USB4 1.0 ENGINEERING CHANGE NOTICE FORM

Title: from CLd state transitions to Disabled State

Applied to: USB4 Specification Version 1.0

Figure 4-8. The Lane Adapter State Machine

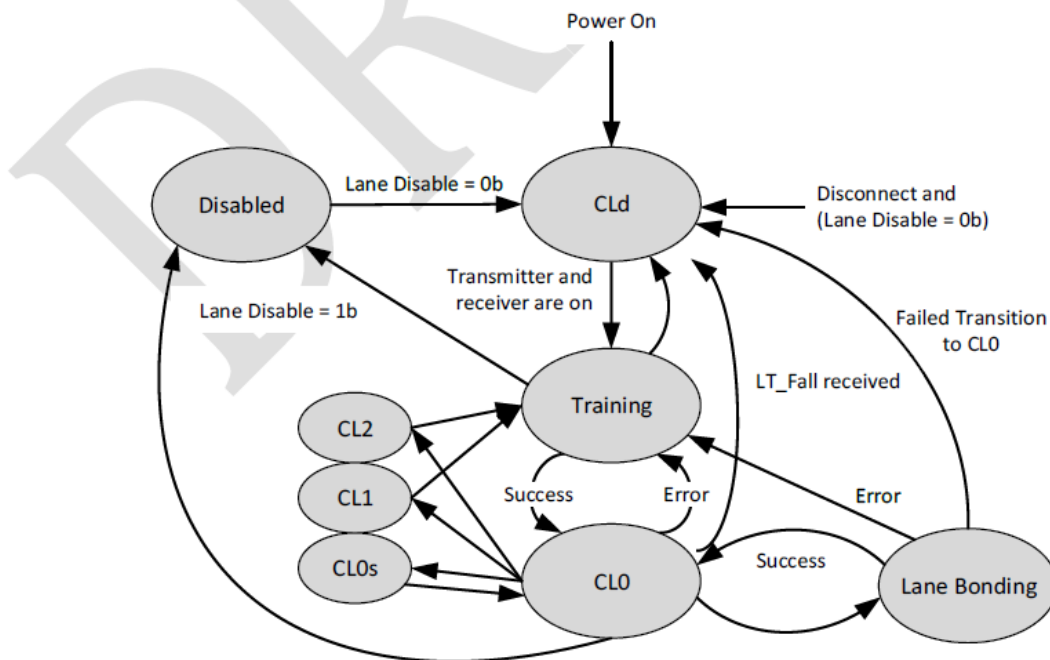
When the Lane Adapter State Machine is at CLd and the Lane Disable bit is set to 1b, the Lane Adapter State Machine shall enter the Disabled state.

(b). Reference

Figure 4-8. The Lane Adapter State Machine
